Macquarie Point Multipurpose Stadium

Public Hearing Technical Note

Technical Note Number	9
Subject	Precinct car park
Date	8 July 2025

Attachment 1
Revised Precinct Car Park Plans

4 SECTION 1 - CAR PARK
SCALE 1 : 200

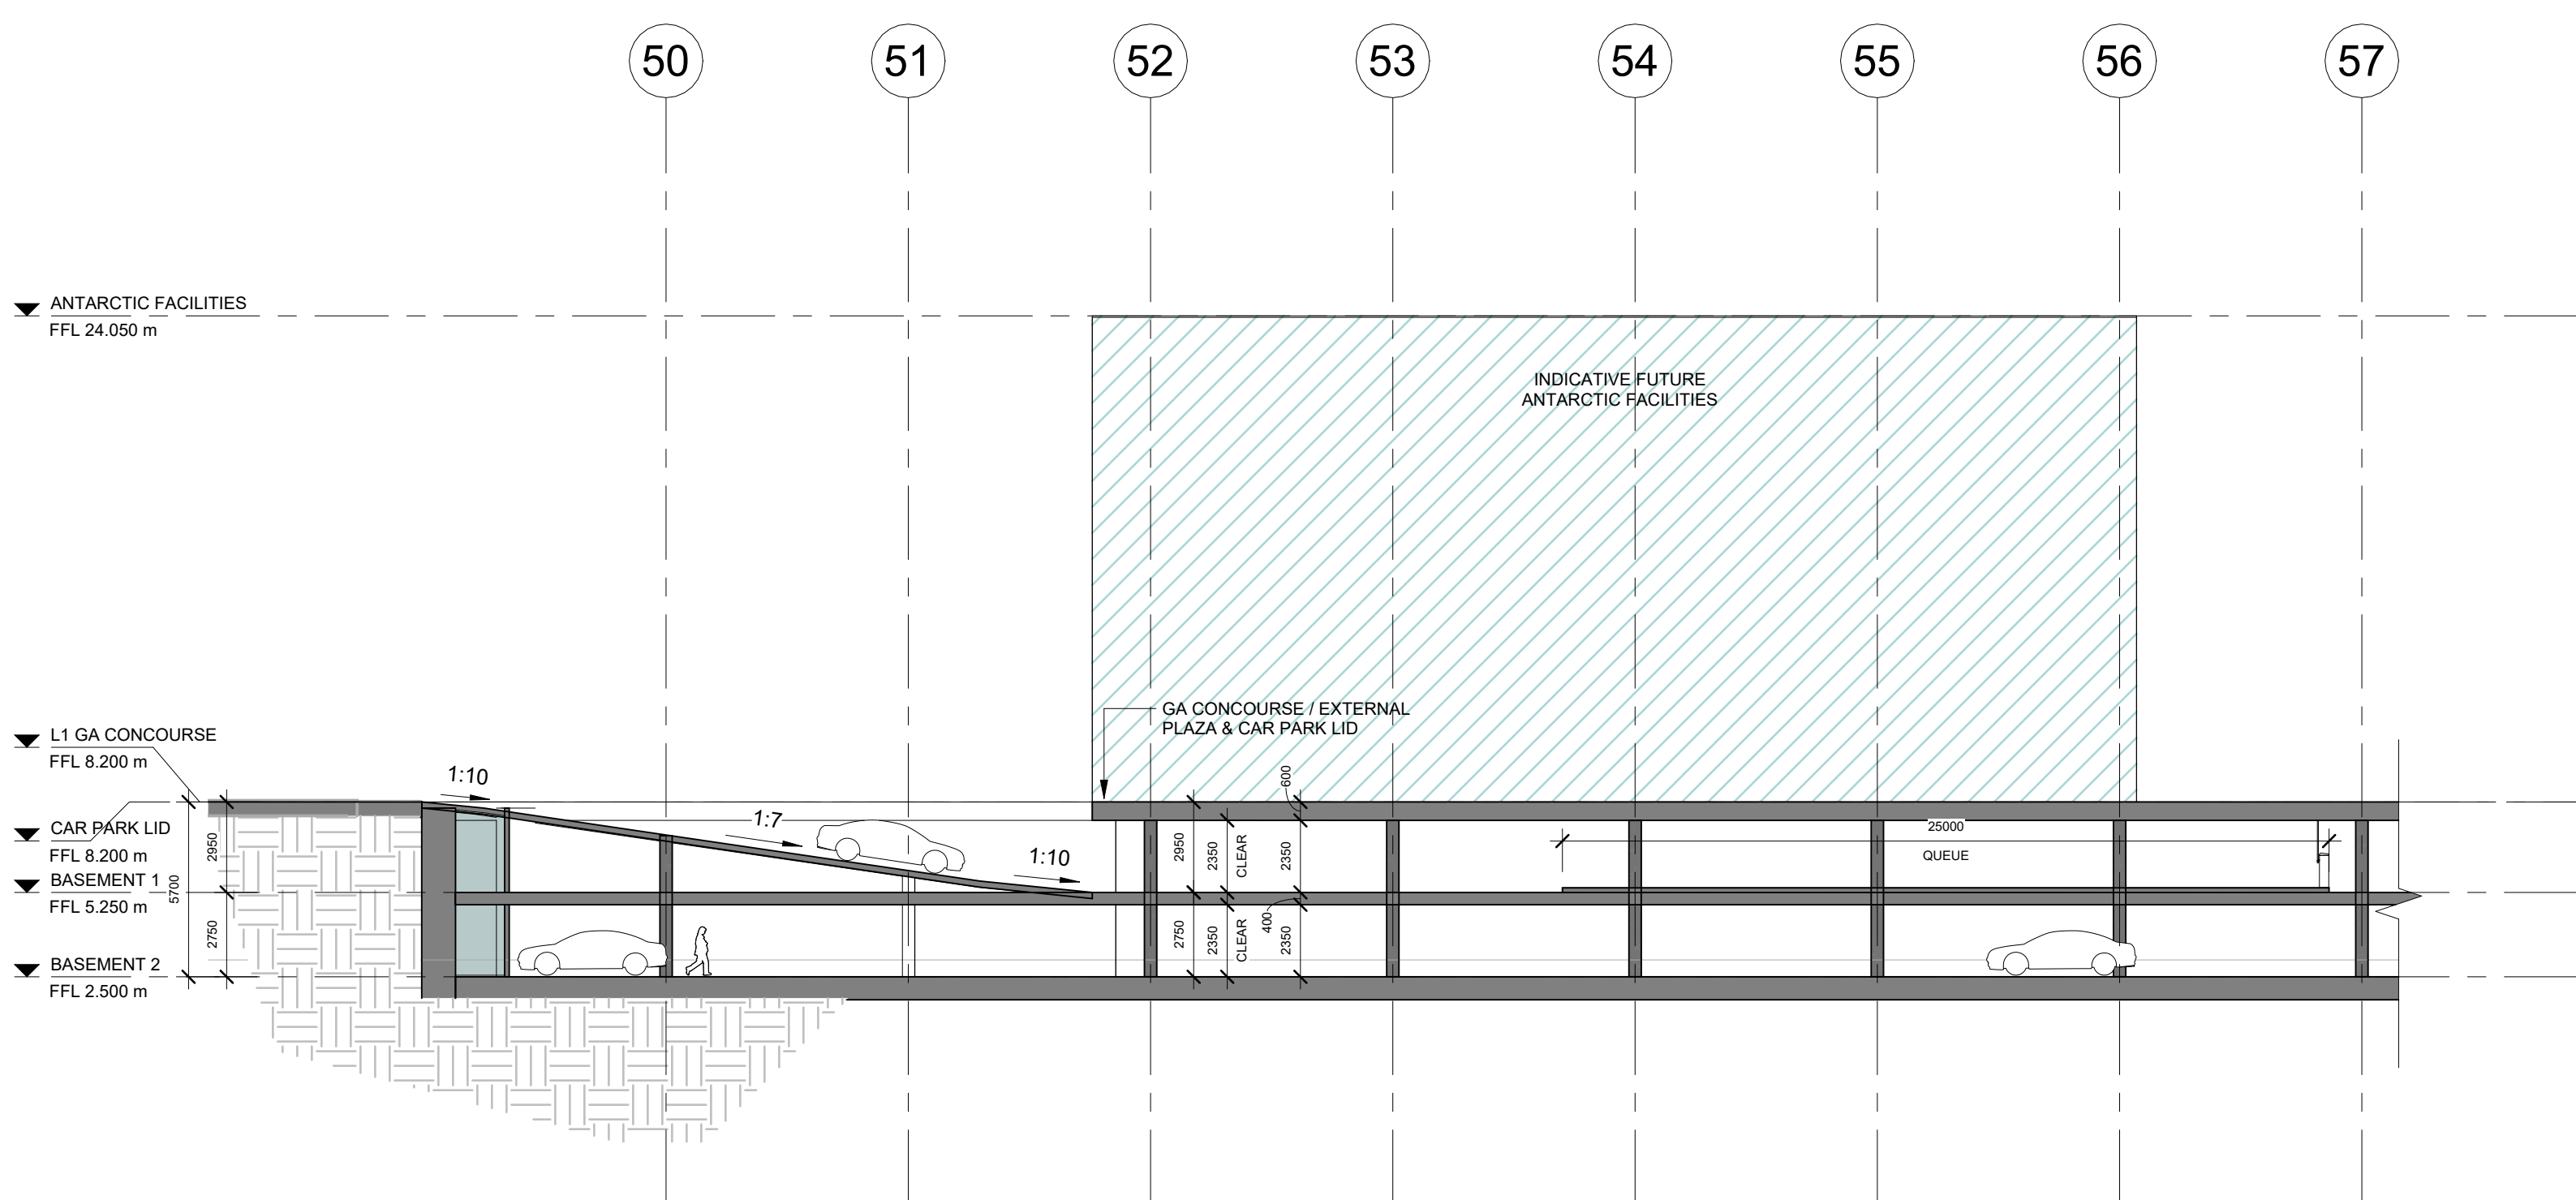
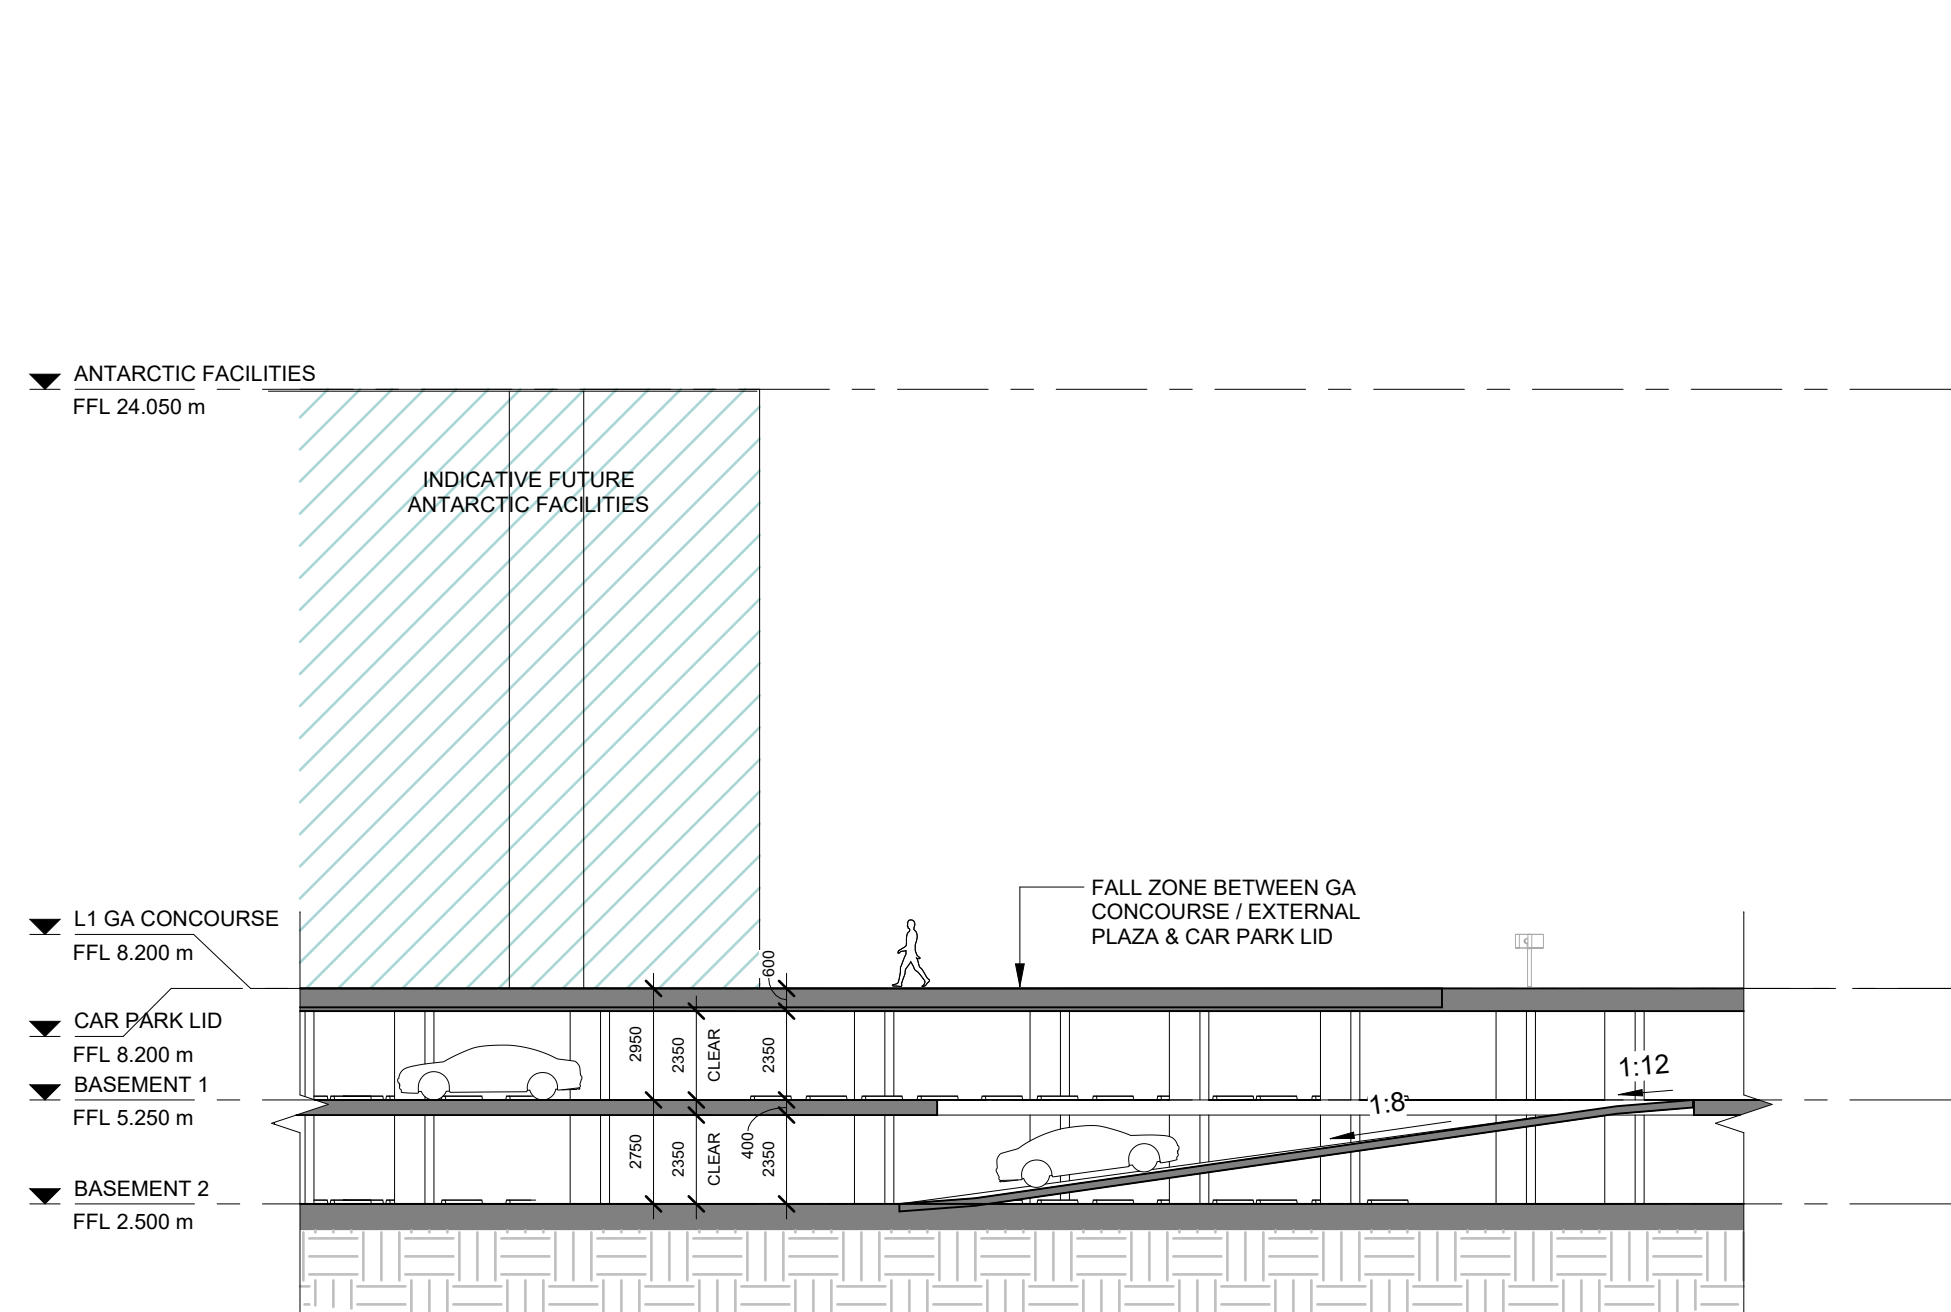
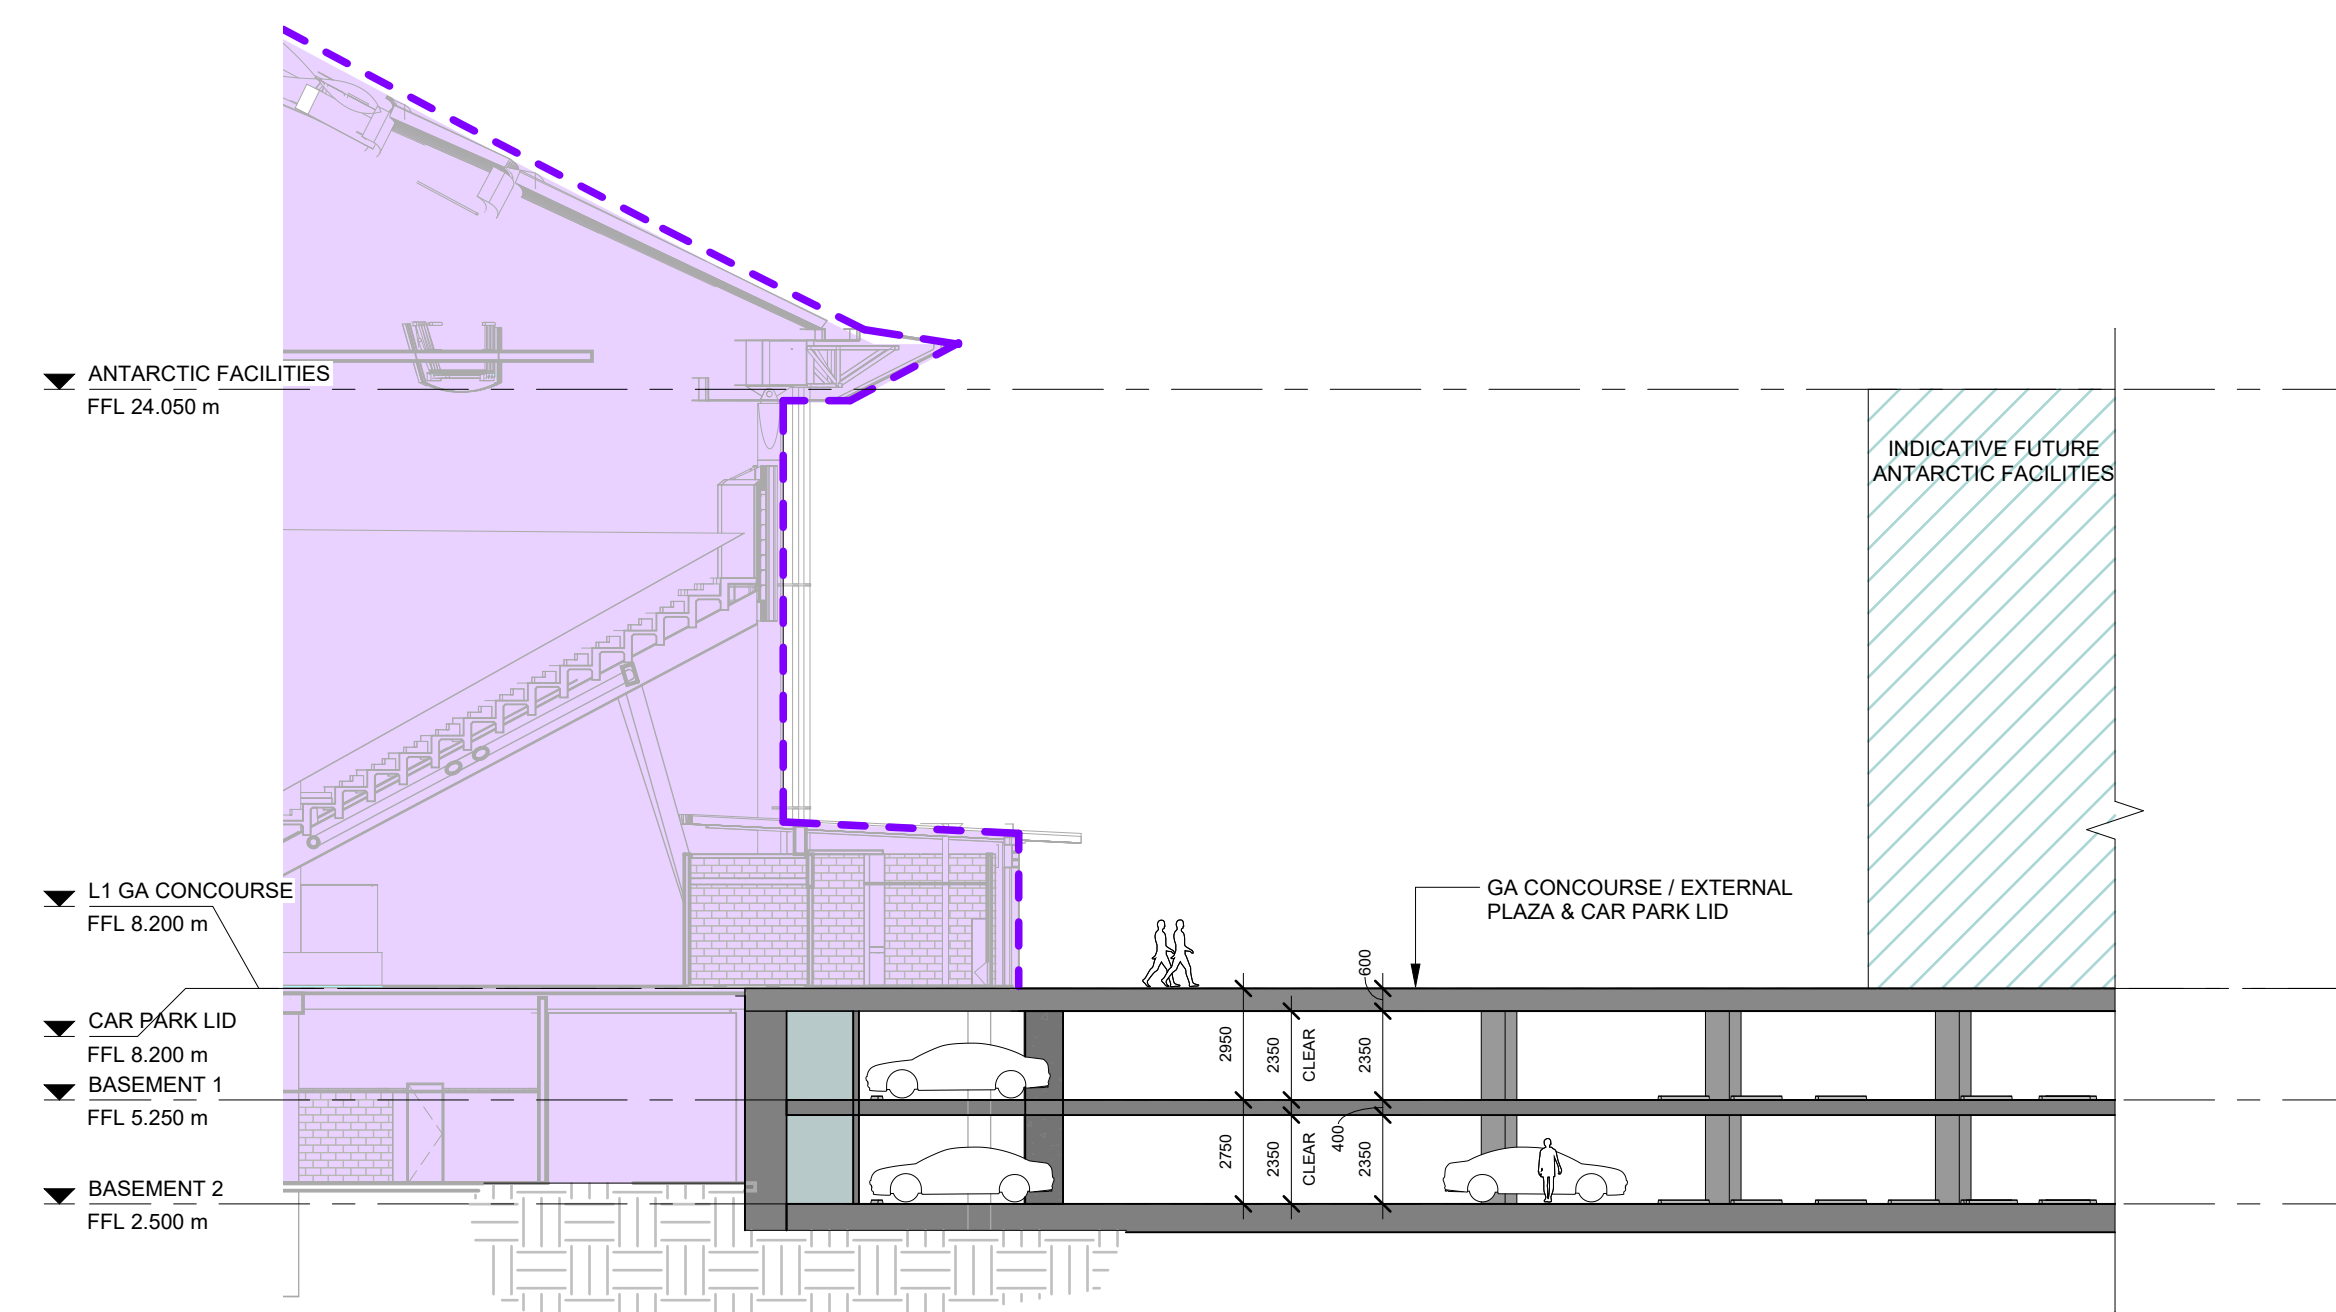
- 2.3 Through the detailed design process and in response to the Draft IAR and representations, the car park has been reduced to two levels below ground. The deletion of one level of car parking keeps the finished floor level to 2.5 relative level which means that the car park remains above the groundwater table. The groundwater table ranges between 1.1 – 1.5 metres AHD in the area where the car park would be located, on average this means the carpark will be approximately 1 metre above the groundwater table. The modified design reduces the scope of environmental matters for regulation and management.

- 2.4 A revised plan is provided at **Attachment 1**, which was also submitted as part of the Technical Note 5 which provides a summary of updates to the submitted plans. The number of car parks shown on the revised plan is 374.
